## Development Permit Panel

1. **DEVELOPMENT PERMIT 16-735007**  
(REDMS No. 5611727)

APPLICANT: Alex Sartori  
PROPERTY LOCATION: 6020 No. 4 Road

2. **DEVELOPMENT PERMIT 17-774155**  
(REDMS No. 5660408)

# SKETCH PLAN SHOWING AREA OF PROPOSED COVENANT OVER ENVIRONMENTALLY SENSITIVE AREA ON LOT "B", BLOCK 64, SECTION 11, BLOCK 4 NORTH, RANGE 6 WEST, GROUP ONE, NEW WESTMINSTER DISTRICT, PLAN 1228

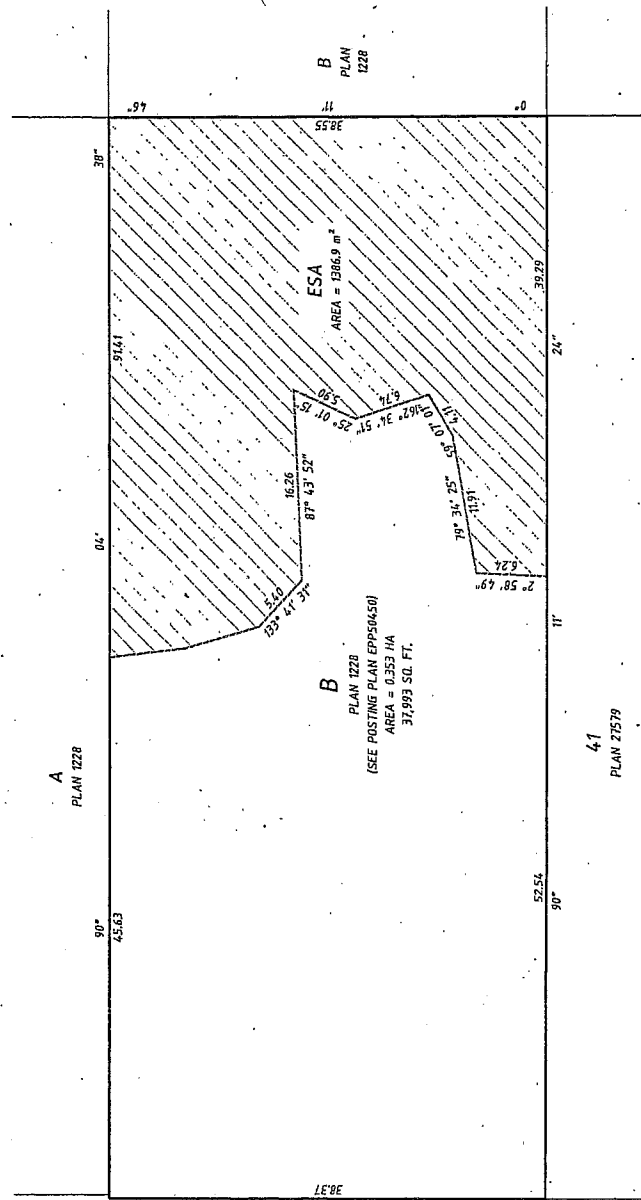
Panel Comment: ***Review and reconcile data provided by staff and the applicant regarding the extent of the proposed development's impacts to the ESA.***

Response: The site plan has been significantly modified by reducing the size of the house and increasing the area proposed to be planted and retained as ESA. The estimated area of the retained and enhanced ESA is approximately 1,934.5 m<sup>2</sup> (20,822.41 ft.<sup>2</sup>). This is an increase of the ESA of approximately 547.6 m<sup>2</sup> (5,894 ft.<sup>2</sup>) from the original application submission. The Development Permit Considerations include a requirement for submission of a sketch plan prepared by a surveyor which will be used to prepare a protective covenant for the ESA areas on the subject site.

| Sheet Name        | Project Name                      | BoutHouse Design Group Inc.   | Date      |
|-------------------|-----------------------------------|---|-----------|
| SITE GRADING PLAN | 6020 NO.4 RD.<br>RICHMOND<br>B.C. | UNIT 3-3331 VIGORS WAY<br>RICHMOND, B.C. V6X 1Y1<br>PHONE: 778-287 7201<br>FAX: 778-287 5501<br>Email: tony.bouthouse@gmail.com | AUG. 2017 |

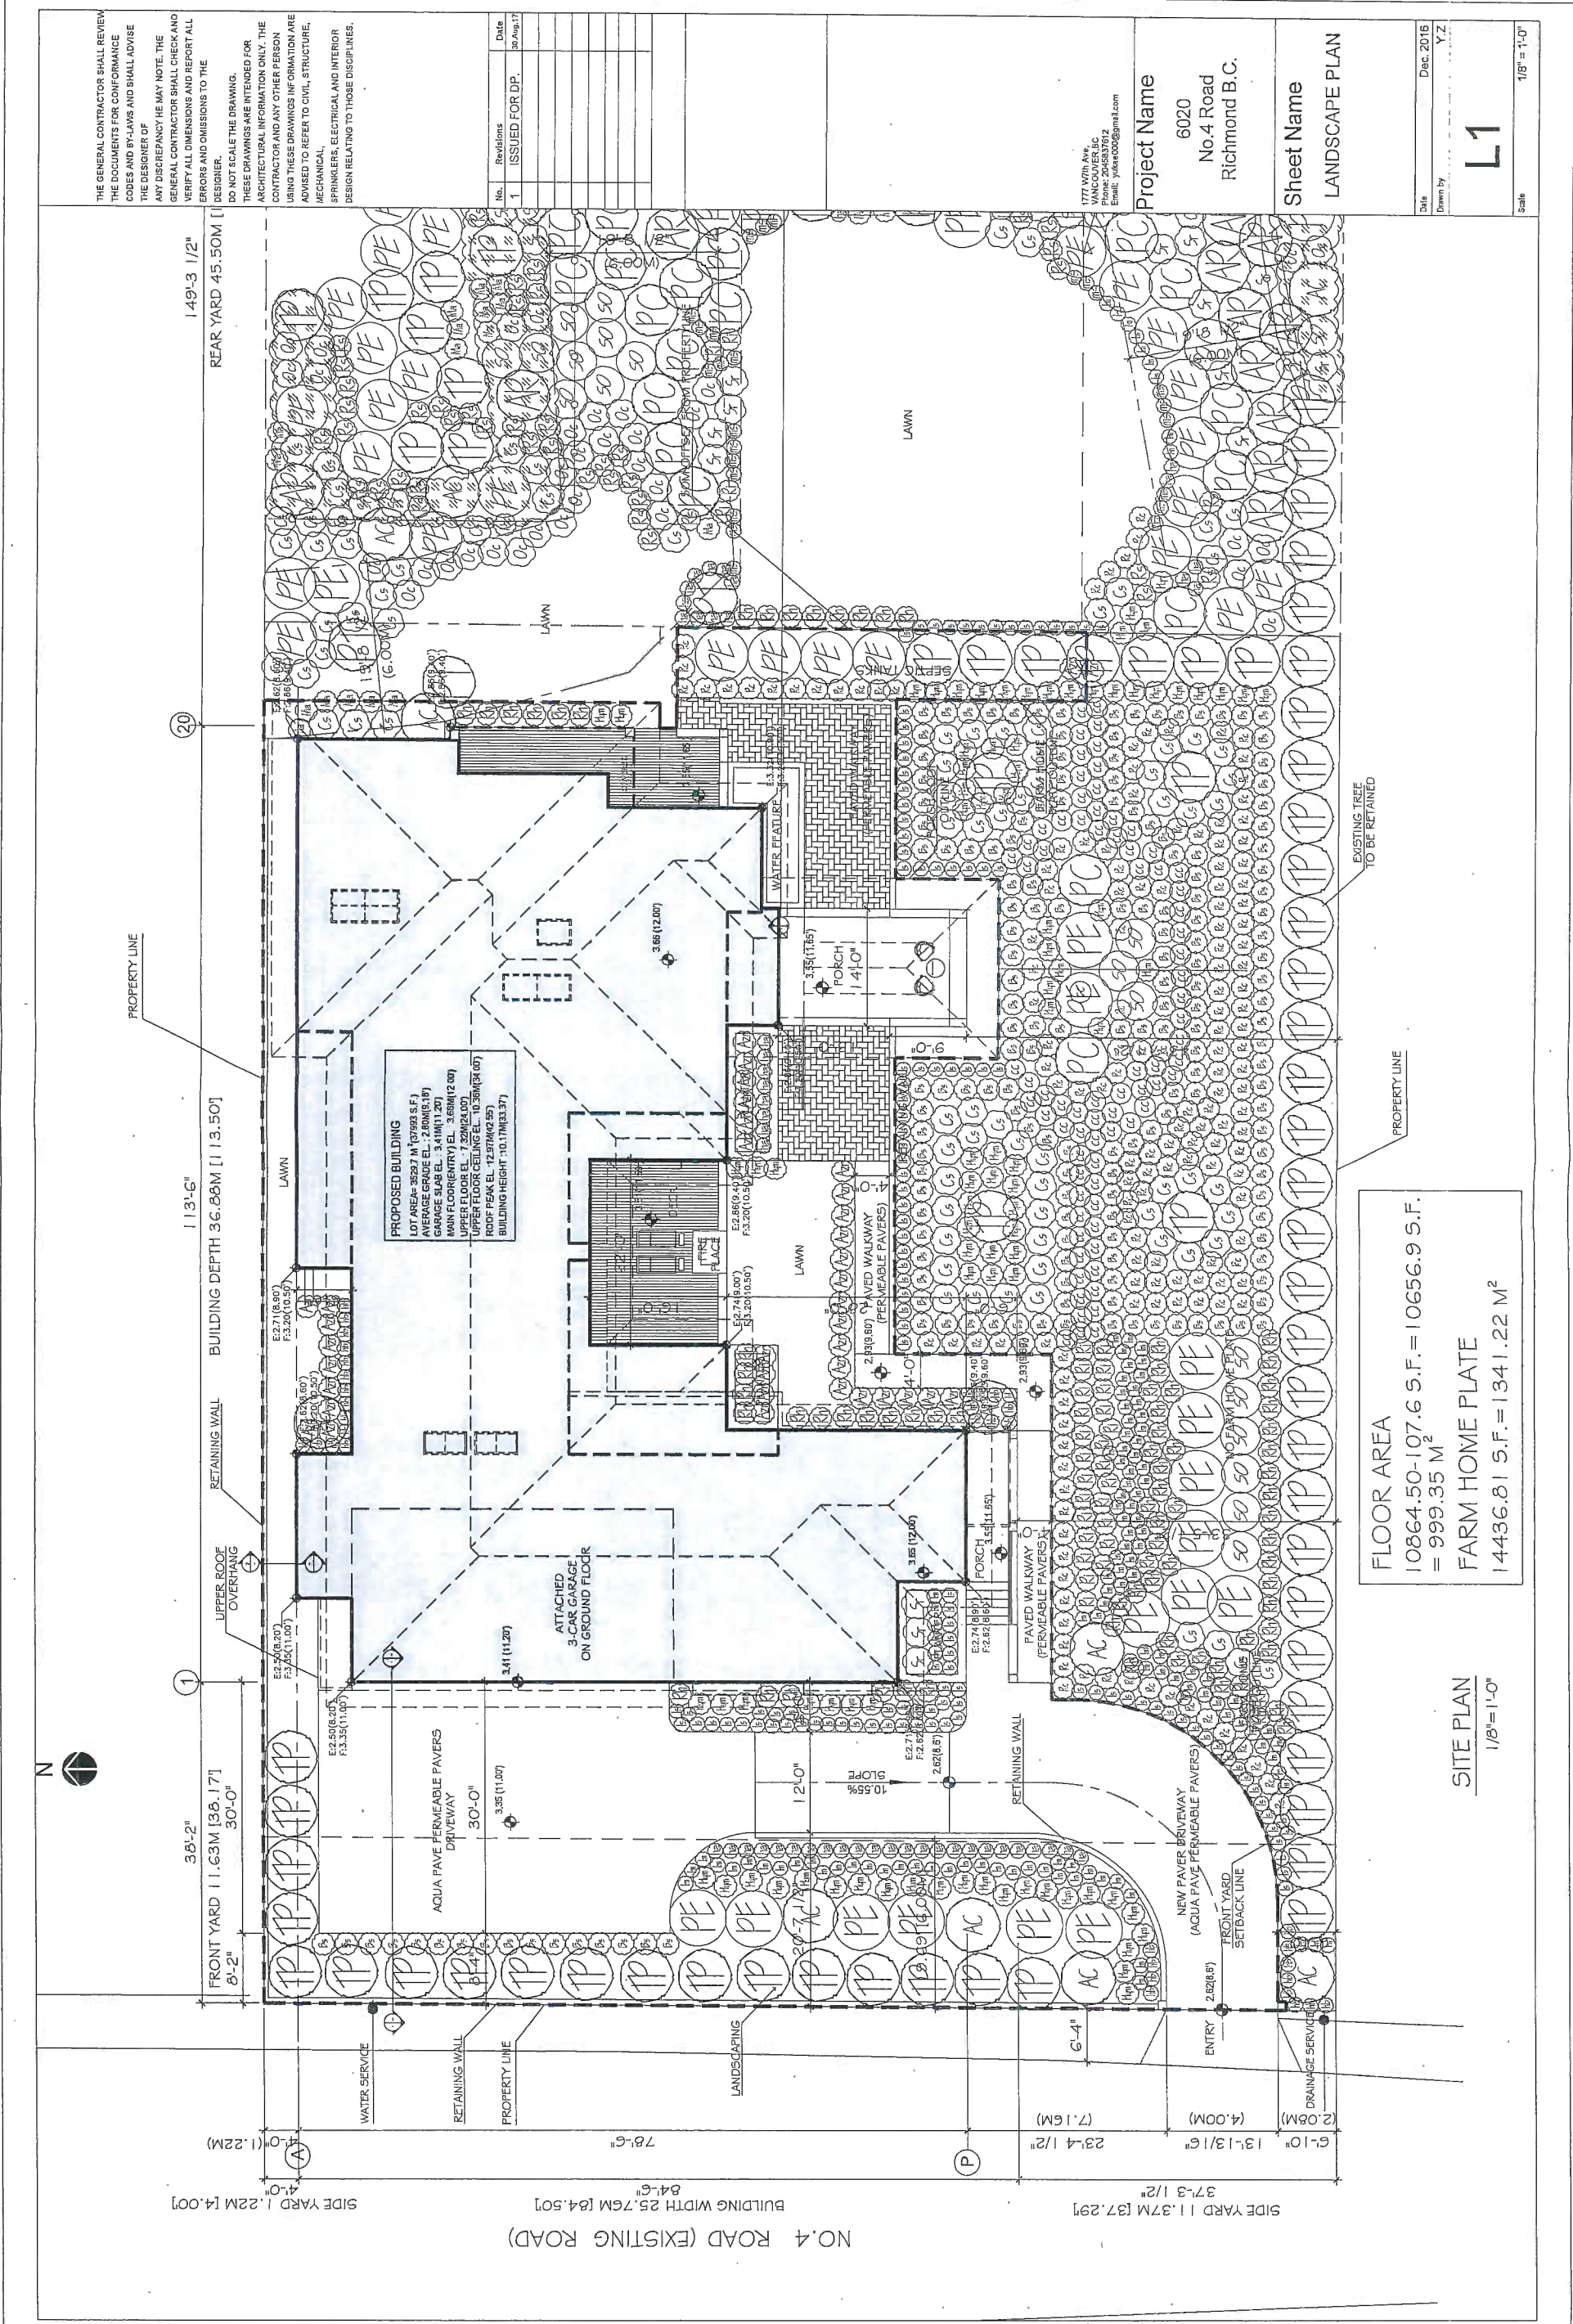
Panel Comment: ***Investigate and address potential impacts of the proposed development to neighbouring properties' drainage.***

Response: An updated grading plan has been submitted showing transitions to the adjacent properties. The grade differences are confined to the western portion of the lot with no grade changes at the rear of the property where the ESA is to be retained. Along the south side of the house the previous driveway will be replaced with native landscaping, allowing more infiltration into the soil. In addition, perimeter drainage will be required as part of the Building Permit application requirements. Perimeter drainage is required around the area being filled – in this case, at the western portion of the site where the house is proposed to be located. This combination of increased ground infiltration and perimeter drainage represent reasonable measures to address the majority of the storm run-off concerns from the site.

Sheet Name  
LANDSCAPE PLAN

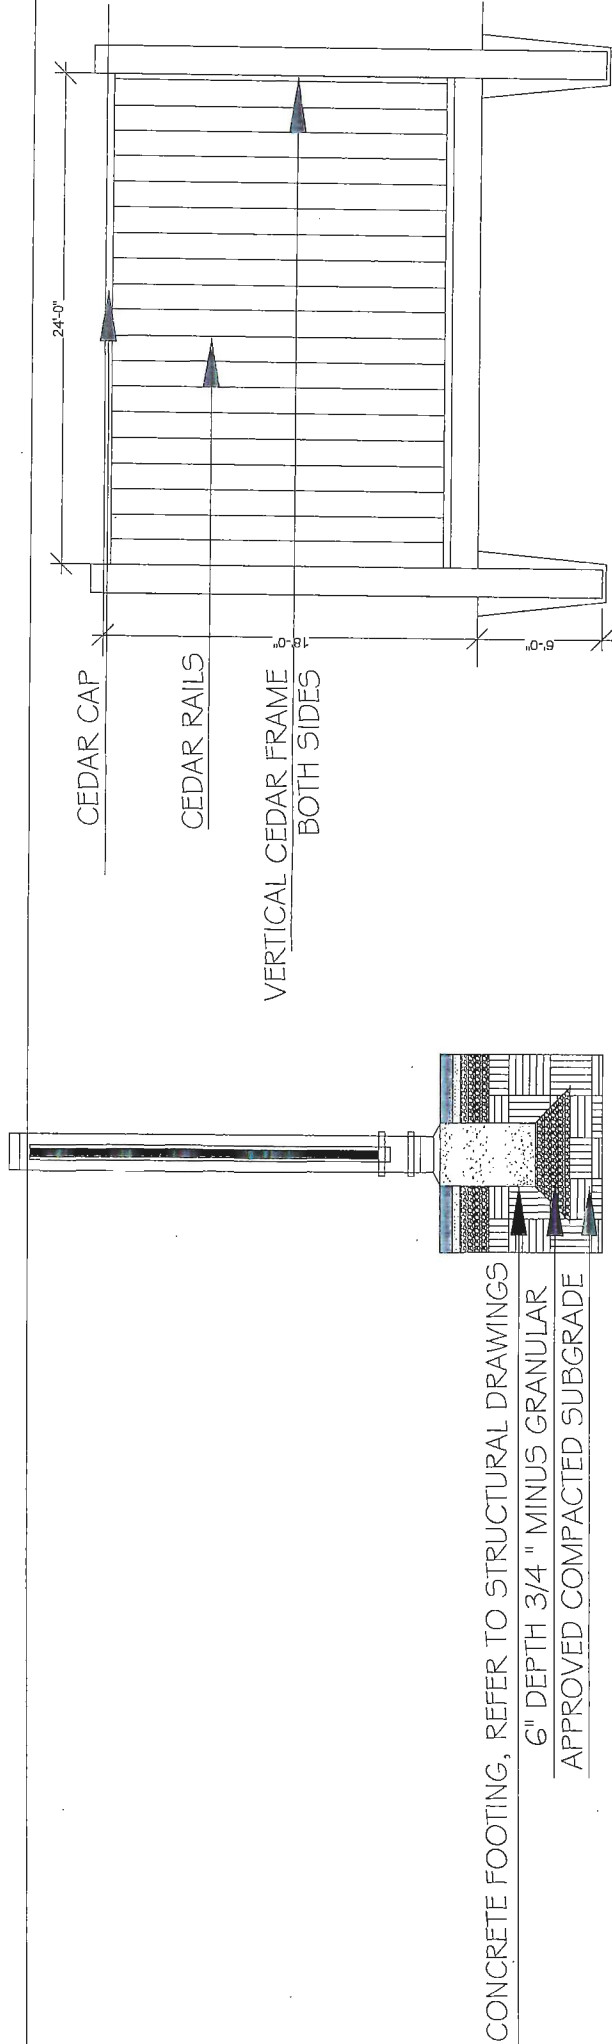
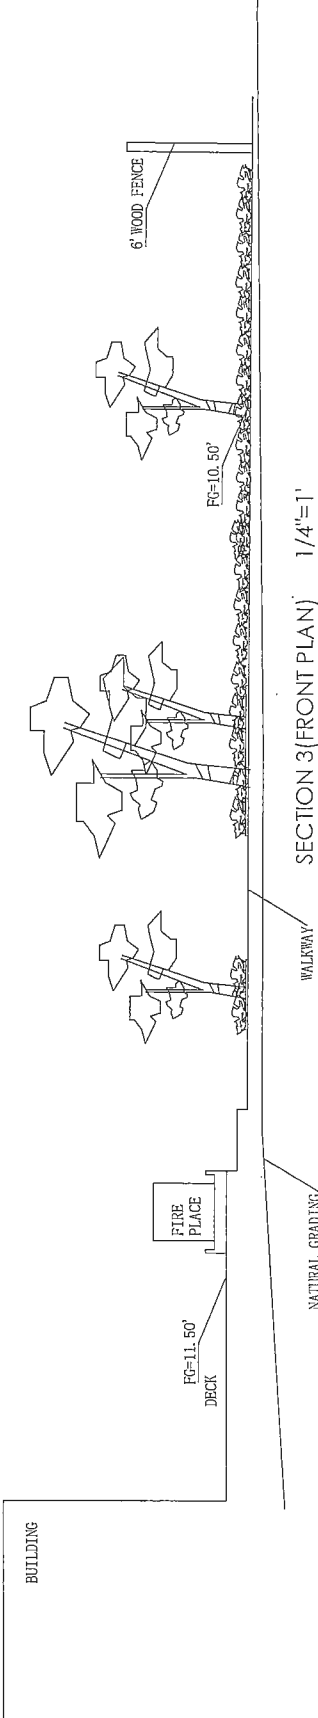
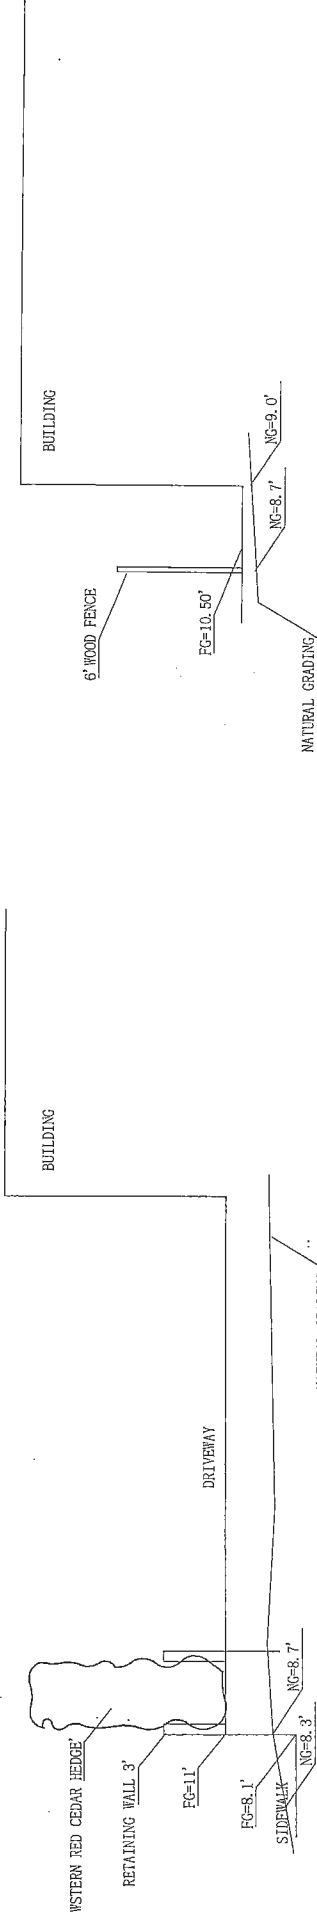
Panel Comment: *Further explain how the proposed landscaping would enhance the redefined ESA and mitigate the development's impacts to the ESA.*

Response: Three areas are proposed to be enhanced under the revised site plan:

- a. In and around the existing tree stand at the eastern end of the property, where invasive vegetation will be removed and replaced with native shrubs and trees.
- b. Across the area previously proposed for a driveway along the south side of the house, which is currently grassed with no trees and few native shrubs. The enhancement plan proposes a variety of native shrubs and trees to be installed; which will allow more opportunities for use by birds and small animals.
- c. Within part of the front yard setback adjacent to No. 4 Road.  
Although this area is not included in the ESA calculations, it is proposed to be planted with a variety of native shrubs and trees replacing the largely grassed area at the front of the lot helping to increase the area of native planted landscaping.

The revised landscape plan will result in approximately 84 more trees and 356 more shrubs than the original submission overall. A total of 282 trees, 977 shrubs and 506 ground cover plants are proposed to be planted on site under the revised landscape plan.
